TOWN OF BERTHOUD PLANNING COMMISSION

THURSDAY, February 27th, 2020

STAFF REPORT: Harvest Ridge Preliminary Plat

PRELIMINARY PLAT
HARVEST RIDGE SOUTH
BERTHOUD, COLORADO
A SUBDIVISION OF LOT 2 AND 3, JOHNSON SUBDIVISION, AND TRACT E,
HARVEST RIDGE NORTH SUBDIVISION, LOCATED IN THE NORTHEAST QUARTER
OF THE NORTHEAST QUARTER OF SECTION 27, TOWNSHIP 4 NORTH, RANGE
69 WEST OF THE 6TH PRINCIPAL MERIDIAN, TOWN OF BERTHOUD, COUNTY
OF LARIMER, STATE OF COLORADO

3 INTERNAL STREET SECTION - DETACHED WALK

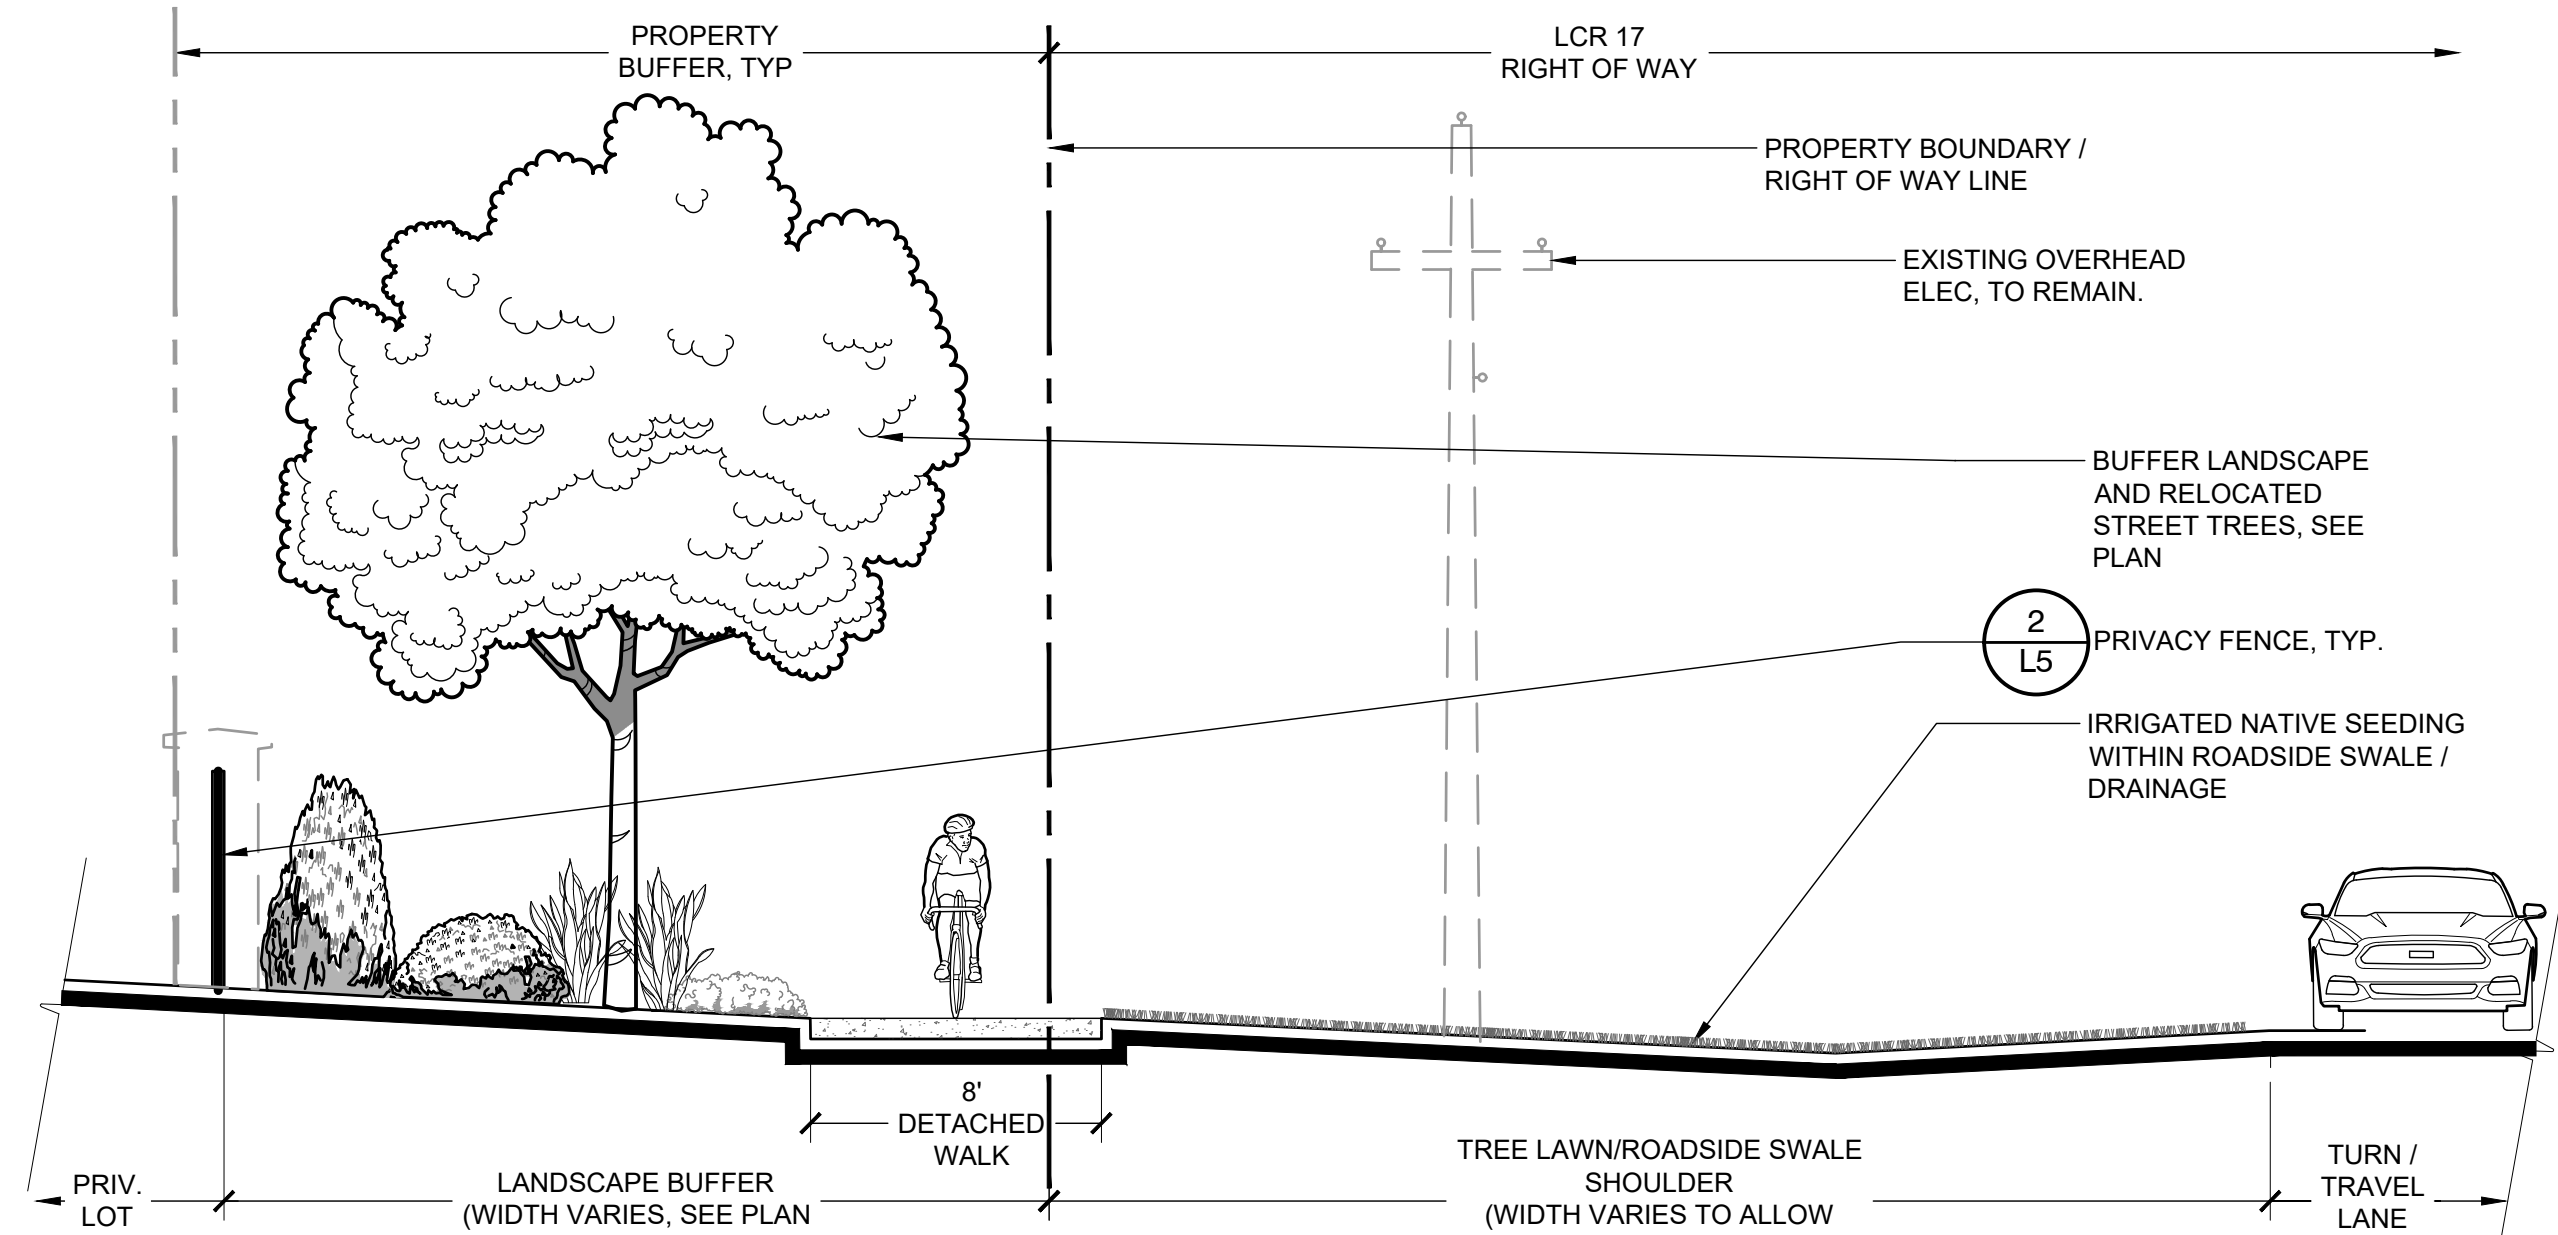
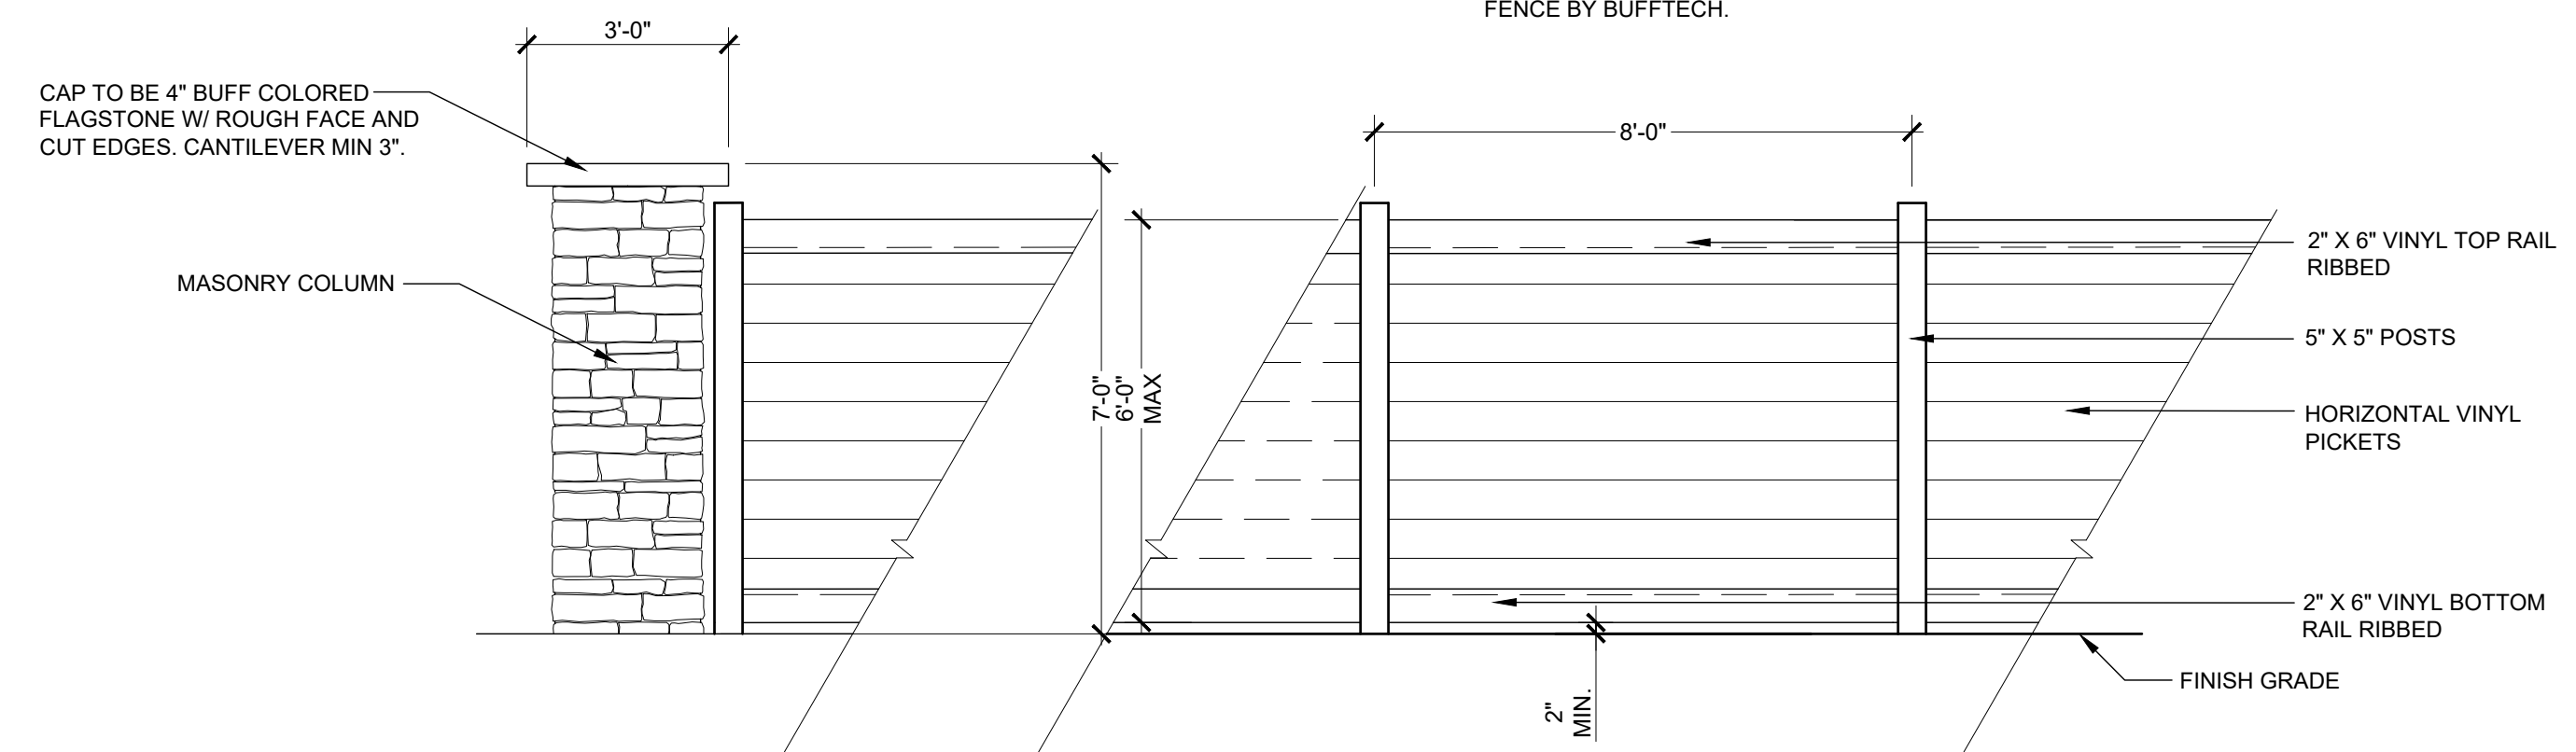
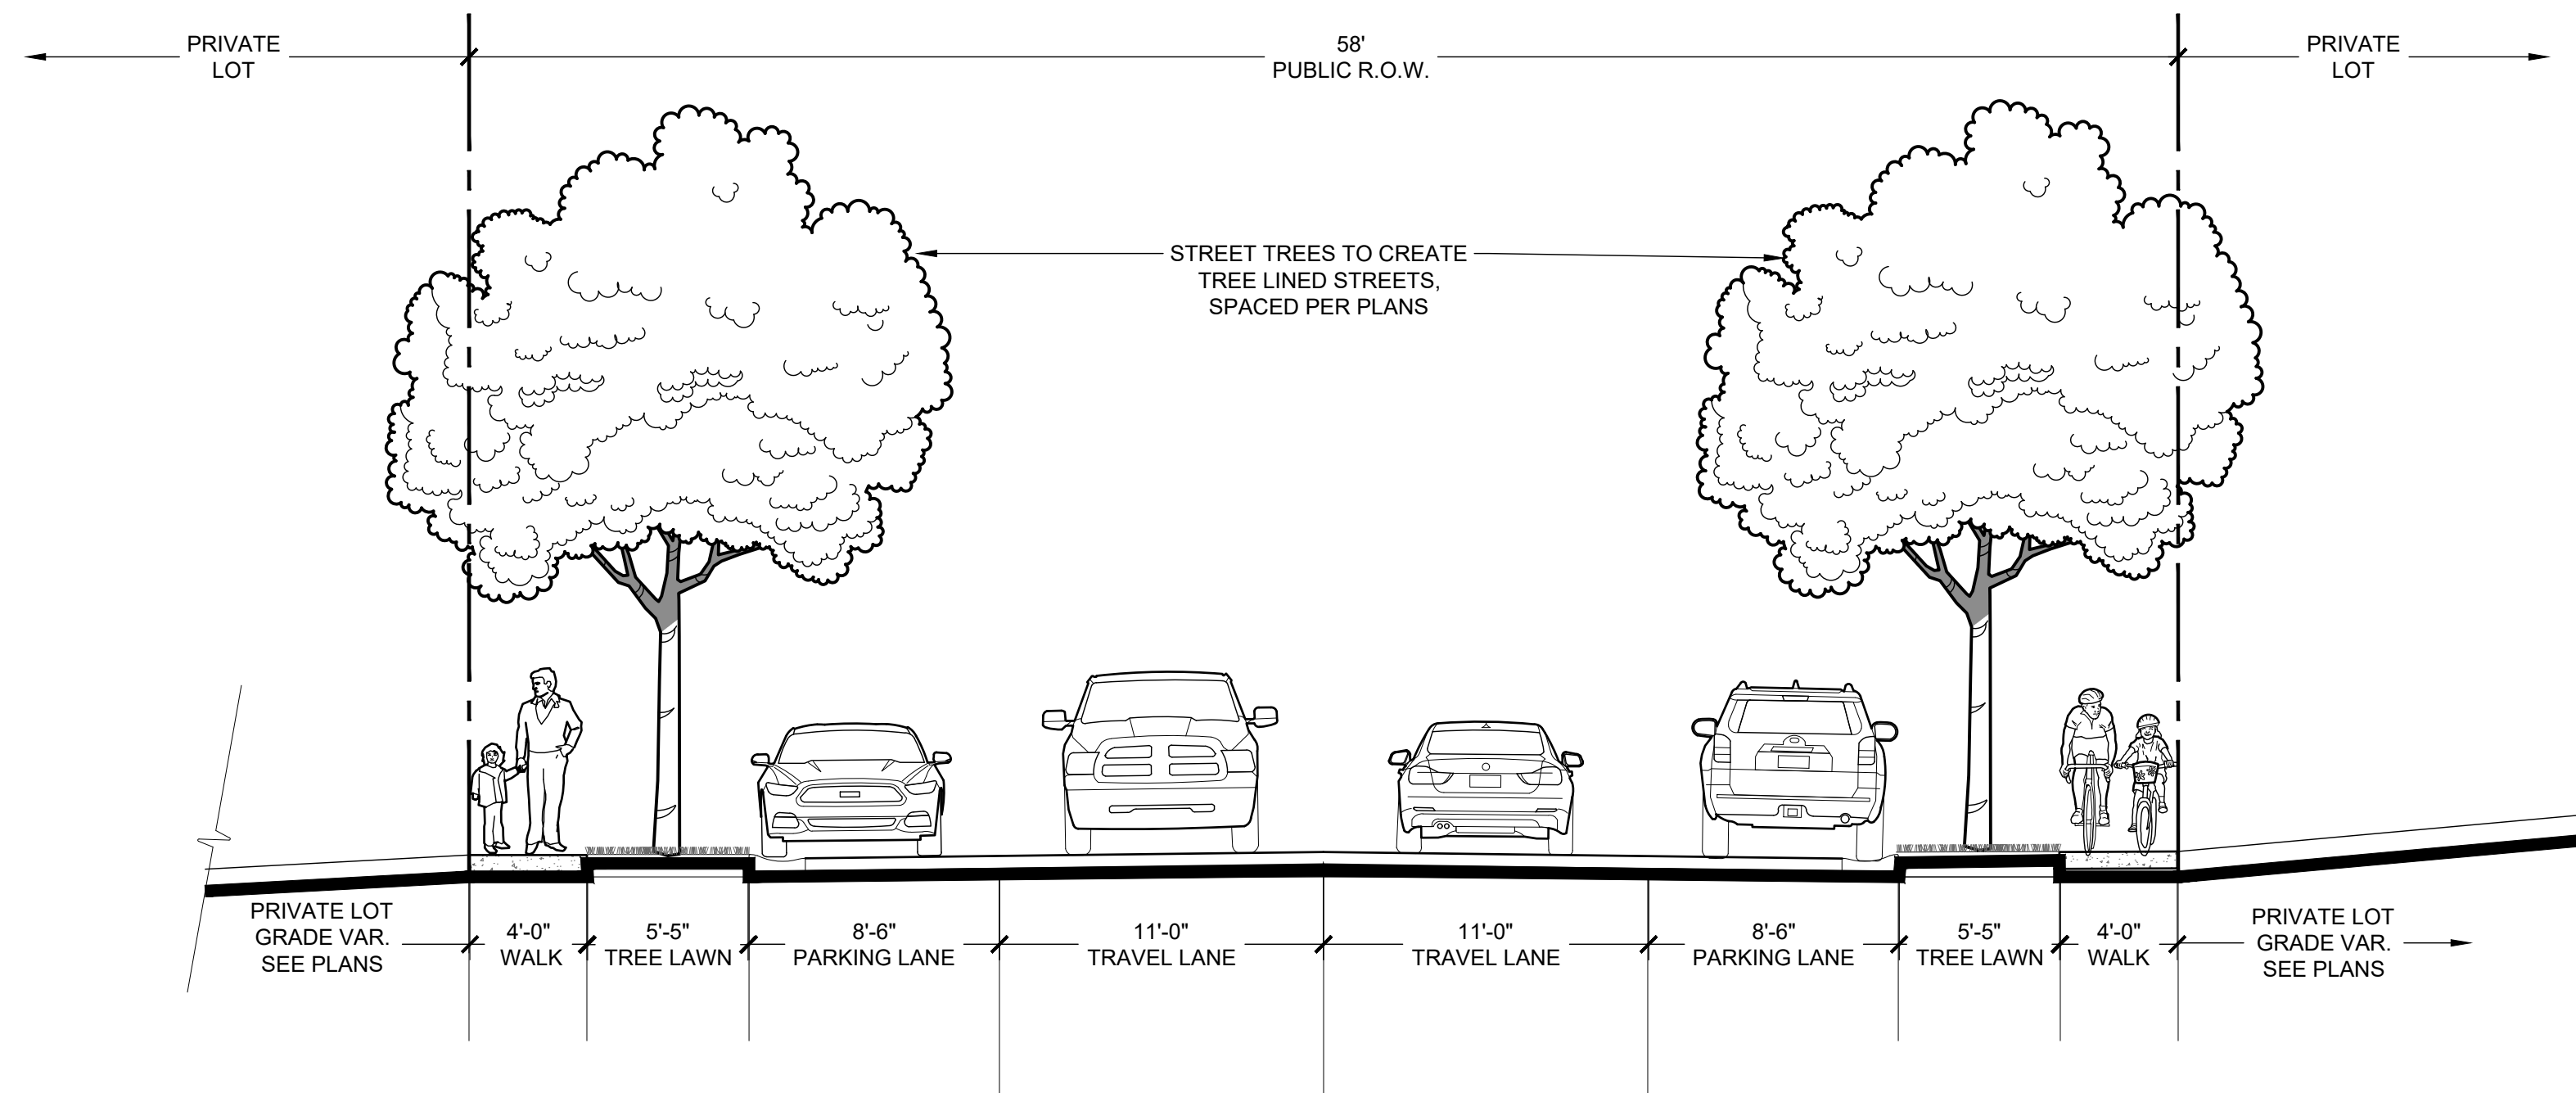
All tree lawns must be 6' in width as per LCUASS Standards (this was a minor detail to be revised at Final Plat, but Staff wants to make sure it is included as the prelim plans show a 5' 6" tree lawn.)
